ITEM 7. DEVELOPMENT APPLICATION: 137-151 CLARENCE STREET SYDNEY**FILE NO: D/2012/1453****DEVELOPMENT APPLICATION NO: D/2012/1453****SUMMARY****Date of Submission:** 20 September 2012**Applicant/Land owner:** Investa Property Group**Architect:** Architectus

Proposal Summary: Stage 1 development application for the demolition of the existing structures on the site and consent for an 80m building envelope comprising ground level retail uses, commercial podium and tower including basement parking.

Figure 10 – Aerial view of proposed Stage 1 building envelope

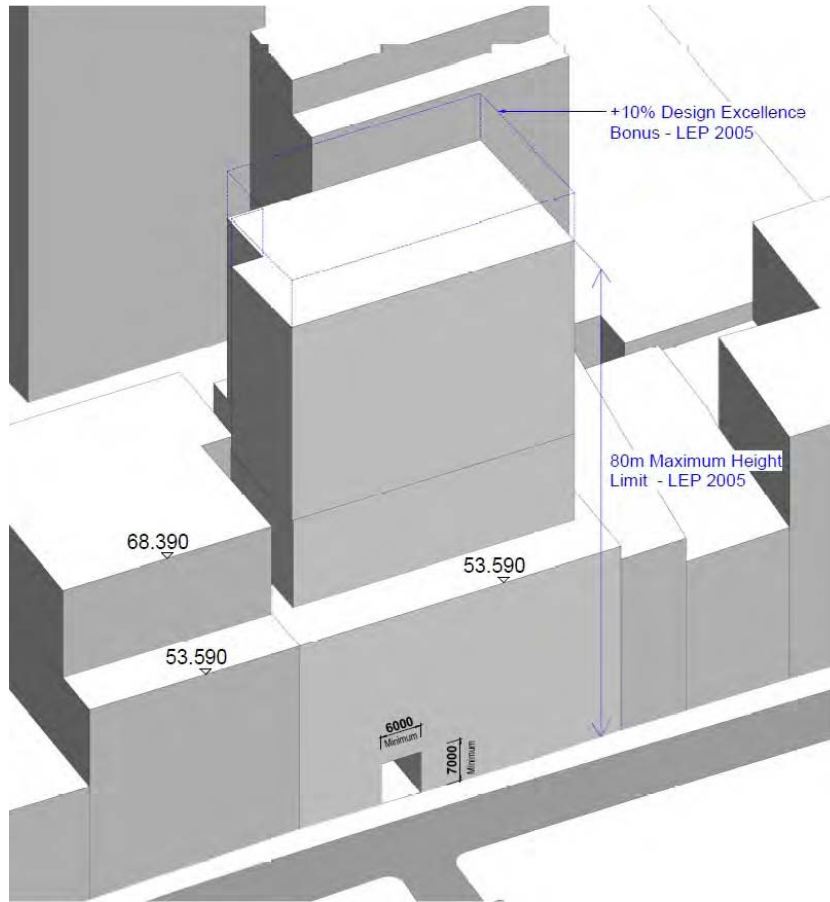
36. The proposal is consistent with the draft height control of 80m. The plans submitted show a 10% design excellence bonus to the maximum height control (88 metres). However, the 10% variation to the maximum height control is subject to a competitive design process and will be applied for at Stage 2 in accordance with the requirements of Clause 6.21(7) of the Draft LEP.

40. As part of this Stage 1 DA, the applicant seeks consent for a floor space area of 23,023sqm. This is a FSR of 11: 1 (based on a site area of 2,093sqm) and includes 10% uplift for completion of a future competitive process.
41. This request is premature and not supported. In noting that the future Stage 2 DA will be considered under the future LEP, the following matters are pertinent in reaching this conclusion:
 - (a) the conducting of a competitive design process does not guarantee design excellence and any uplift in FSR;
 - (b) any uplift is 'up to 10%'; and
 - (c) amongst other things, the consent authority will need to be satisfied that the proposal exhibits design excellence.
42. The maximum permitted FSR is 10:1 (without 10% uplift) for commercial development. This represents 20,930sqm.

46. The request to 'lock in' 160 on-site parking spaces is not supported. In particular, the following matters are noted:
 - (a) there are currently 120 vehicle spaces identified on the site over two levels of basement and includes car parking spaces to service the site service. Forty-seven (47) of those car parking spaces are 'stacked parking';

Figure 11 – Clarence Street (east) elevation

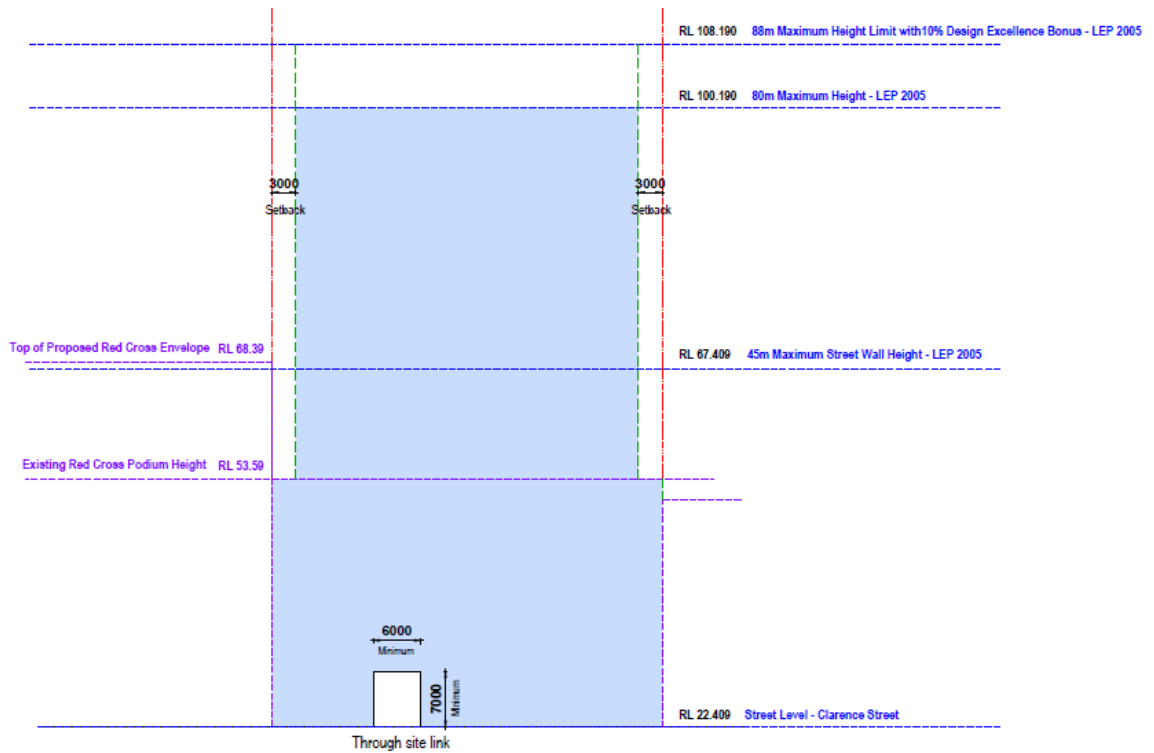
50. Any future Stage 2 design as it fronts Clarence Street and Kent Street should respond to major horizontal elements of the former Hoffnung and Co warehouse (Red Cross House) in a similar manner.

51. The proposed height of the proposed Stage 1 envelope of 80 metres is in accordance with the requirements of the *Sydney LEP 2005*. The proposed setbacks of the tower above the podium are consistent with the Central Sydney DCP Section 2.3 and respect the adjacent heritage item, being 3 metres from the side boundaries, and eight metres from both the Kent and Clarence Street frontages. Signage zones on side elevations are not supported.

- (a) The design of the building should respond to the high quality masonry facades of the surrounding palazzo and warehouse development comprising masonry facades of high quality, strong visual depth, a high degree of architectural modelling and articulation, a complex hierarchy of vertical and horizontal proportions and changes in architectural treatment with height and level, and high quality materials that provide a compatible response to surrounding development should be incorporated into the design.

- (b) There are significant axial views to the site looking west to the site from the former GPO building and from Barrack Street that should be enhanced by the architectural design of the Kent Street façade. There are significant views from the site to the east along Barrack Street, towards George Street, down to the Sydney General Post Office Building that should be taken advantage of, and enhanced by careful framing.

- (c) The design for the development should respond to major horizontal elements of the former Hoffnung and Co warehouse in a similar manner.
- (d) The above design elements are to form part of the design competition brief.

Figure 12 – Section – north elevation

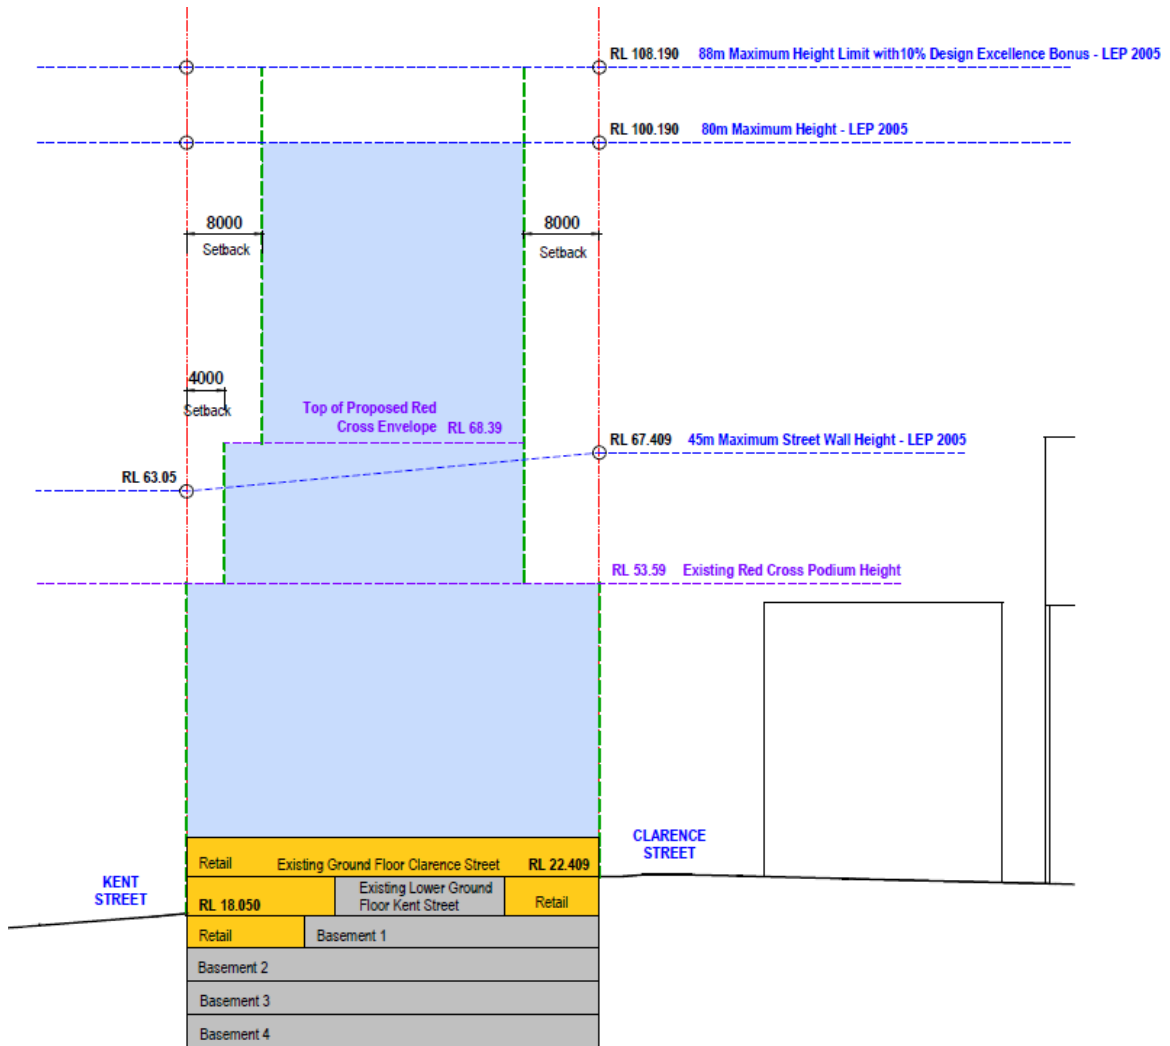
52. The interface with all neighbouring buildings will require careful resolution so as not to unnecessarily expose any side boundary walls.
53. It is considered that the sharing of driveways and the connection of below ground parking levels between the subject site and the adjoining Red Cross House is investigated prior to any Stage 2 application. The planning intent behind the sharing of driveways is:

- (a) A visually interesting treatment is to be applied to the exposed side elevations along the north and south boundaries. In applying this treatment, care should be taken to ensure that there are no unreasonable impacts on the neighbouring properties. Details shall be submitted as part of the future Stage 2 Development Application.
- (b) Signage zones are not permitted on the side boundary elevations.
- (c) The above design elements are to form part of the design competition brief.
